Case Number: PZ23-00005 (SUB)

Staff Report
 PZ23-00005 (SUB)
 Canyon Vista Subdivision
 Summary Sheet

Re: Letter of Intent and Comment Response for Canyon Vista – Preliminary Plat Submittal

PRELIMINARY PLAT CANYON VISTA

Section 5.4.E(1)b.3 Driveways and Access

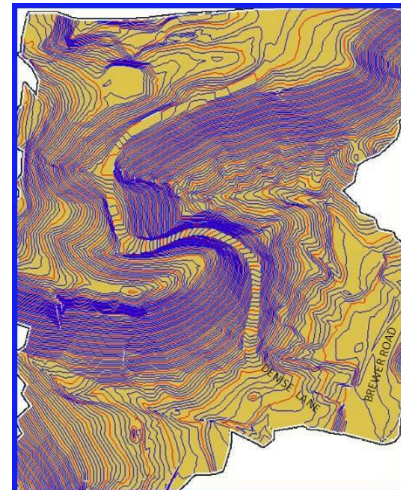
Shared driveways are provided to the maximum extent feasible to minimize the number of access points to streets (except for driveways within residential subdivisions or along private residential streets).

In compliance. We have made some changes to the driveways in the area. Lots 4 and 5 will now share a driveway, so we no longer need a second connection to Brewer Road. Additionally, to reduce the impact on the neighbor to the southeast, we have consolidated the driveways for Lots 1, 2, and 3 with a shared driveway.

SHEET TITLE:	PRELIMINARY PLAT
PROJECT TITLE:	CANYON VISTA SUBDIVISION
DRAWN BY:	TBJ
SCALE:	AS SHOWN
DATE:	02-11-2025
PROJECT NO.:	140505
SHEET NO.:	V-2

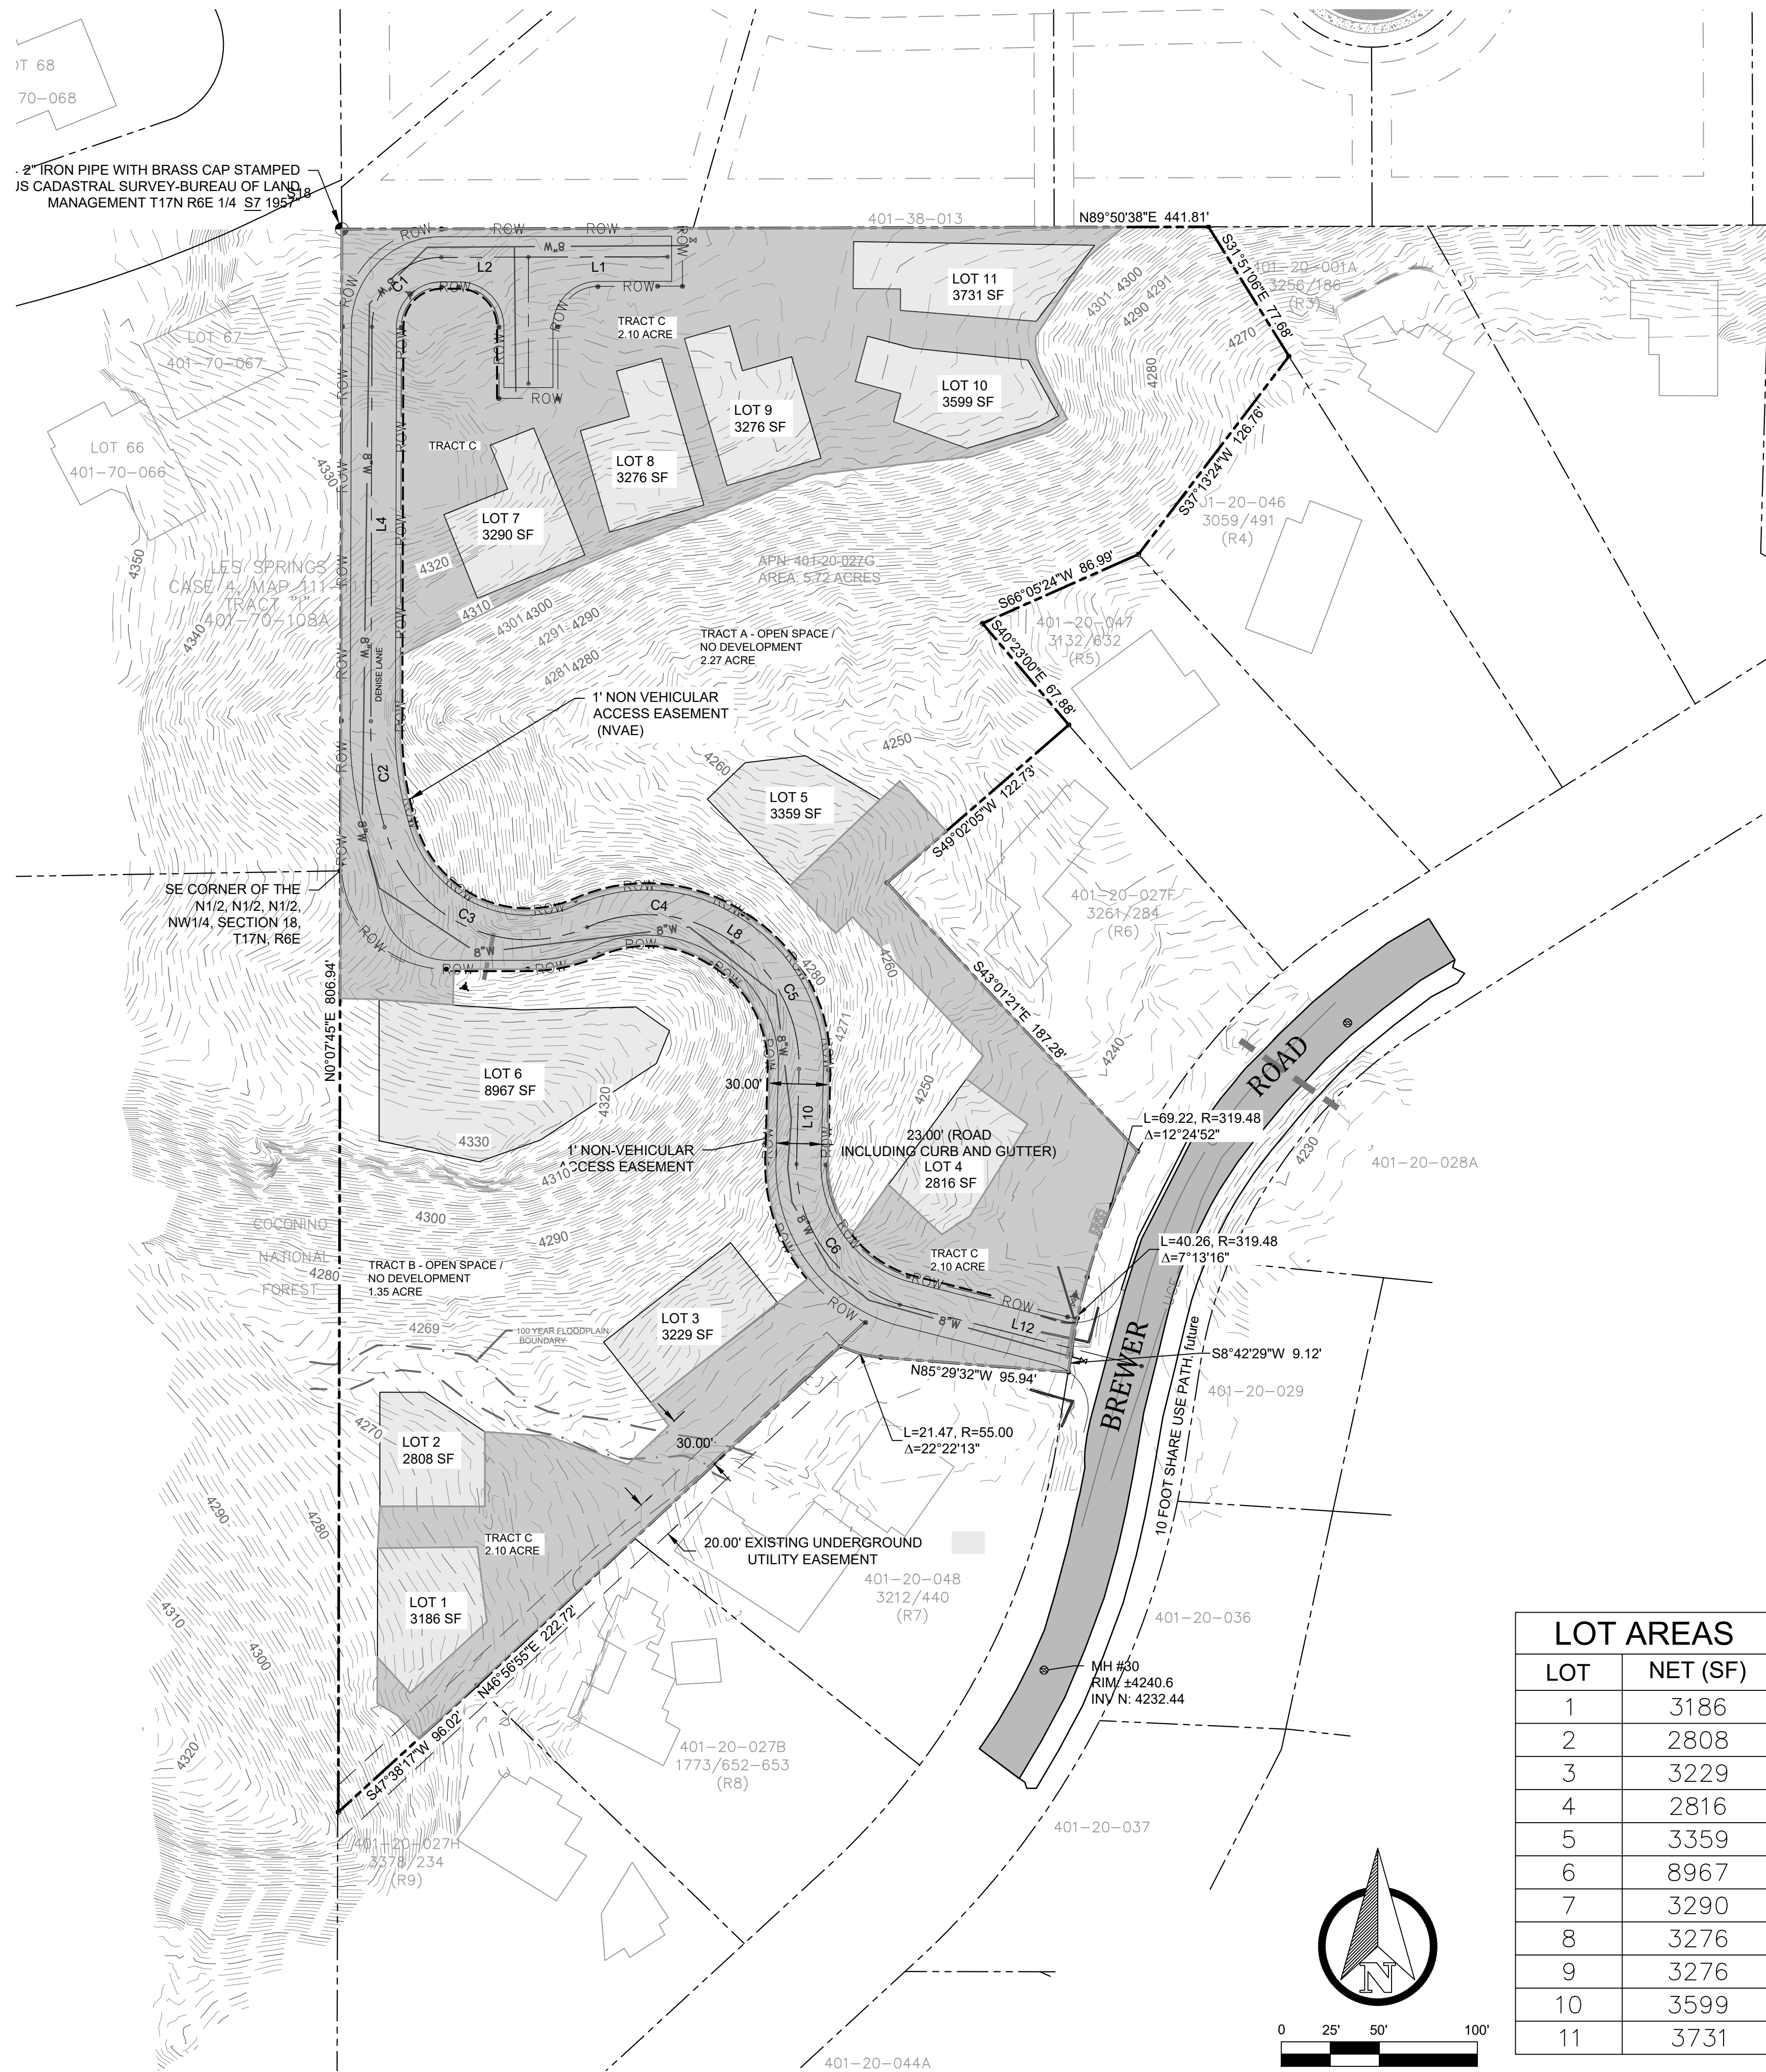
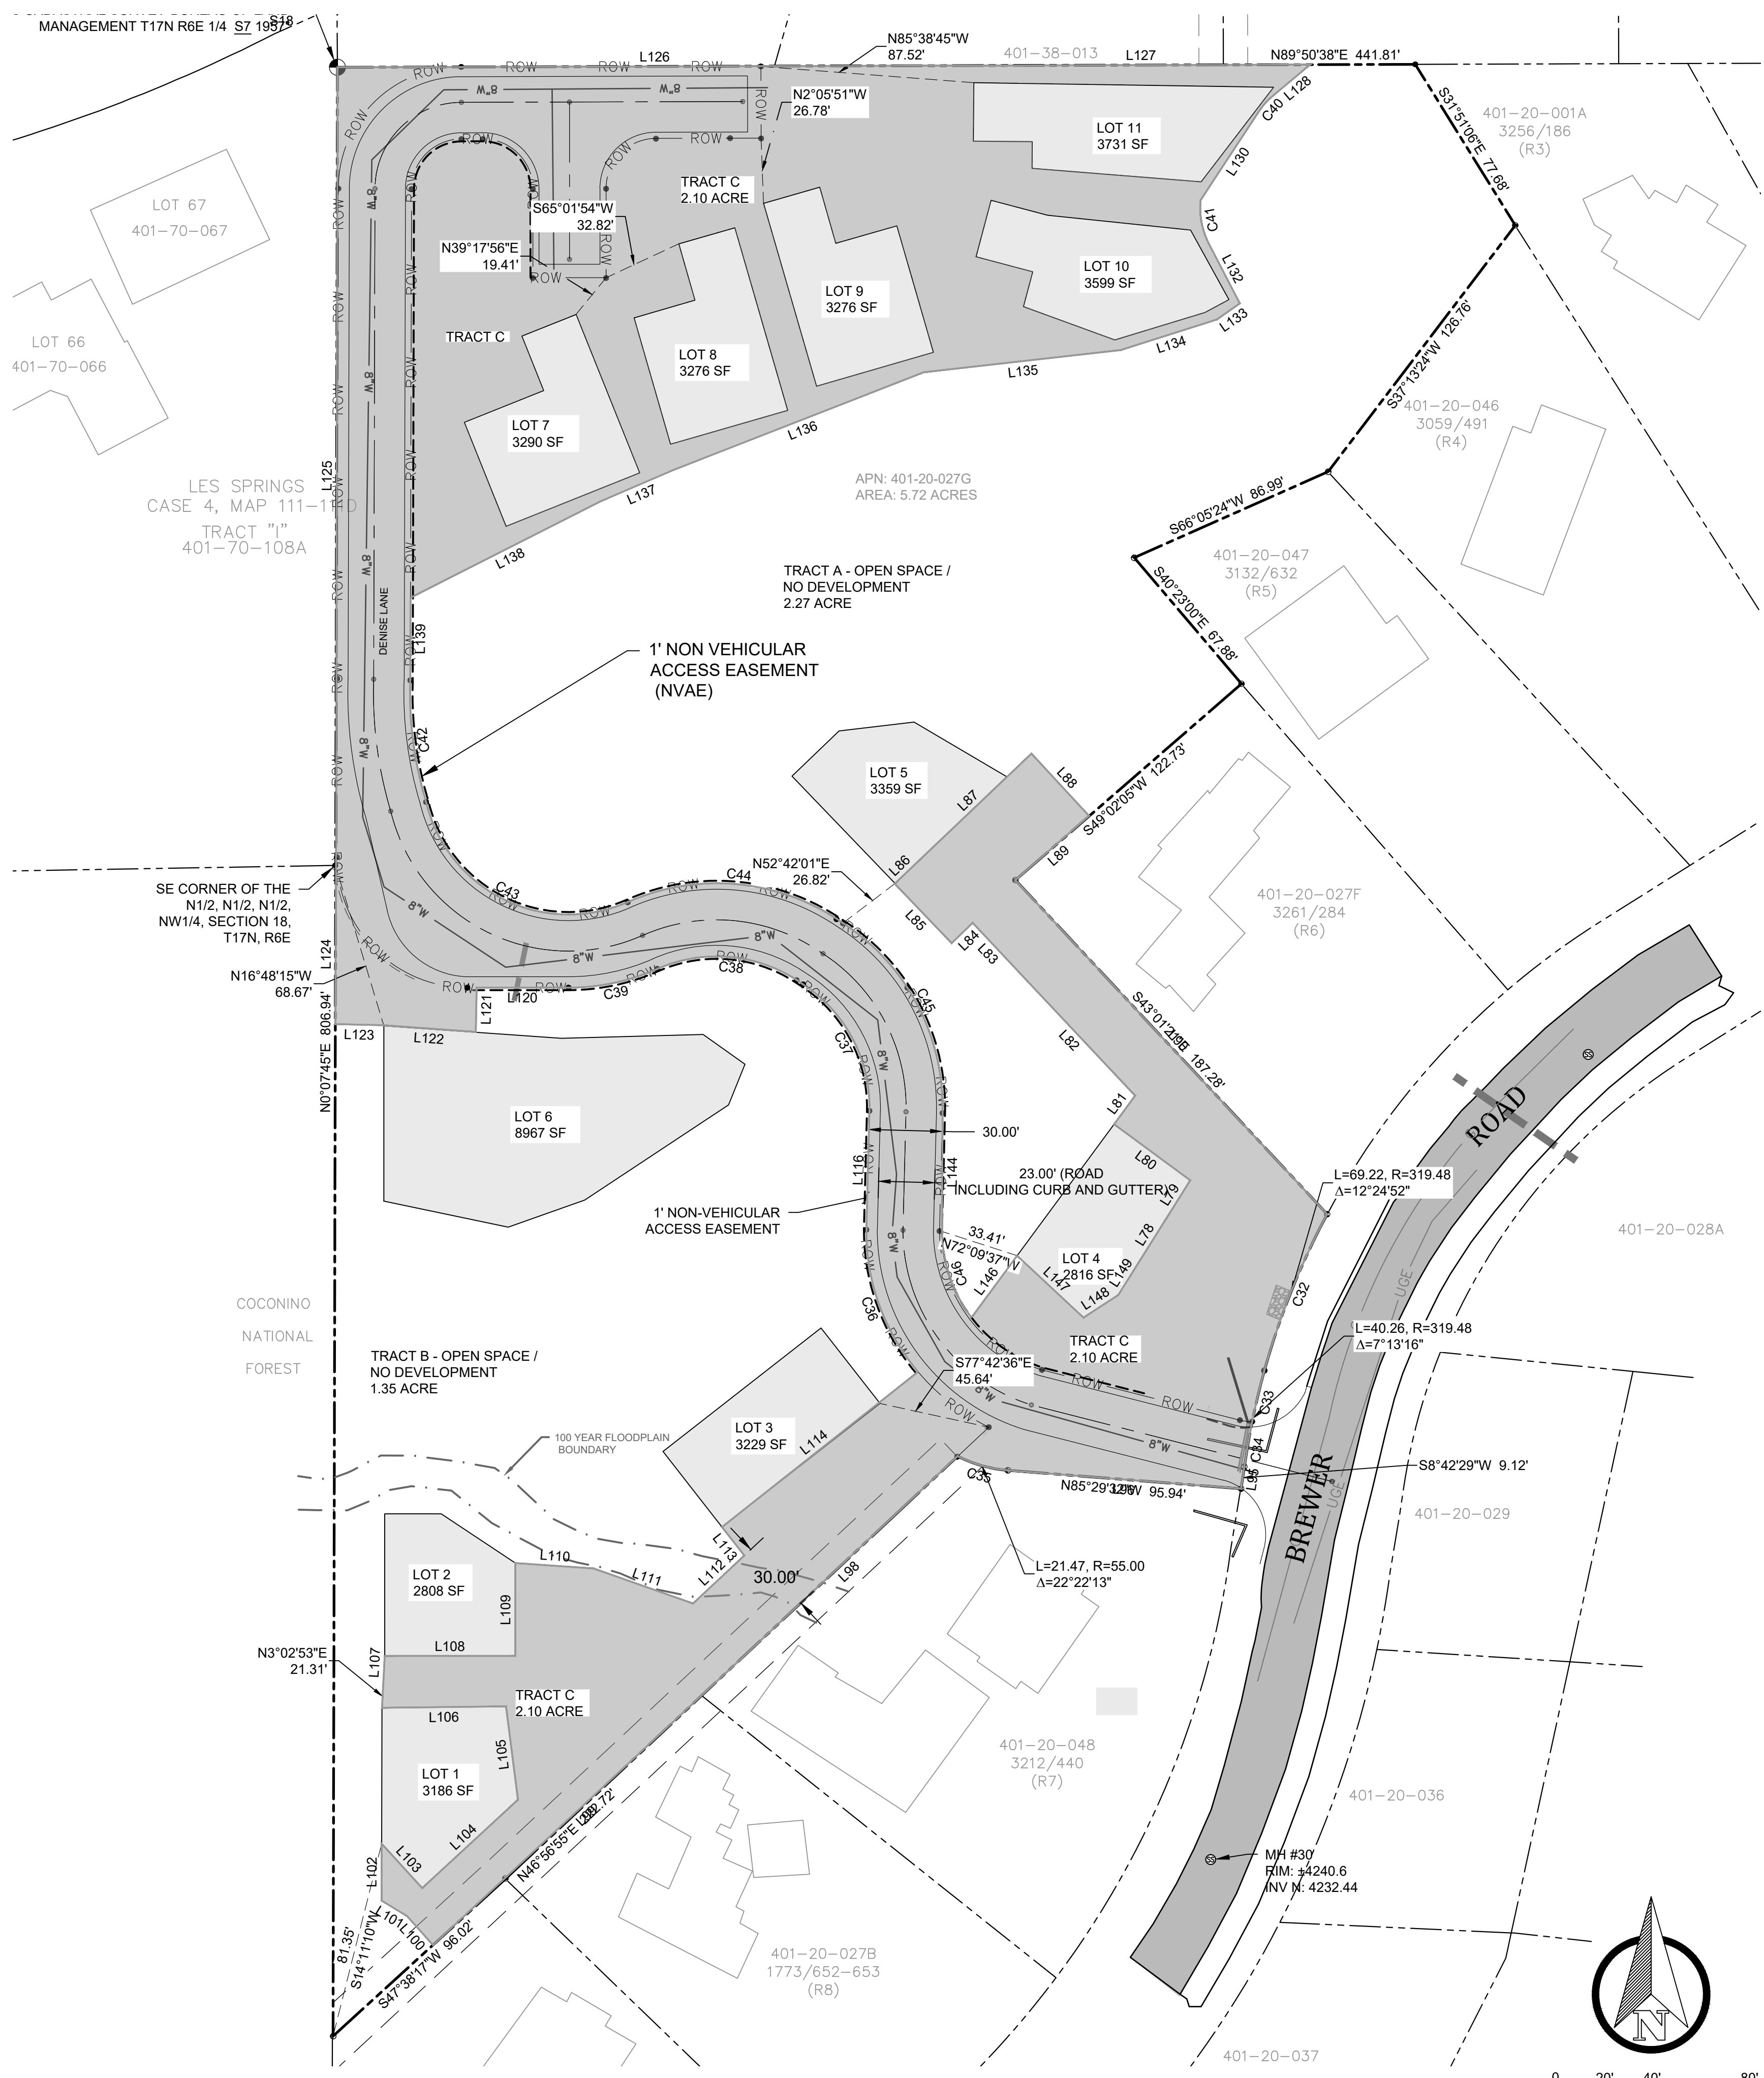
1. Legend items are not consistent.
2. "Hatch Legend" on Preliminary Plat sheets is backwards – in the legend, the hatch used for “Residential Lots” is used on Tract C on the map and vice versa.
3. Line weights on the plat do not match line weights shown in the legend.
4. Declaration and Dedication on Sheet 1 refers to Tracts as Lots.
5. Sheets need to be numbered as XX of YY.
6. Arrows calling out beginning and end of Non-Vehicular Access Easements (NVAE) are in the wrong locations.
7. Scale on the Sewer and Water plans is incorrect (Scale shows 1”:20’, plans drawn at 1”:40’)
8. Public Works/Engineering has identified the following as needing be removed from the plat:
 - a. Topography
 - b. Curb/Gutter/Edge of Pavement
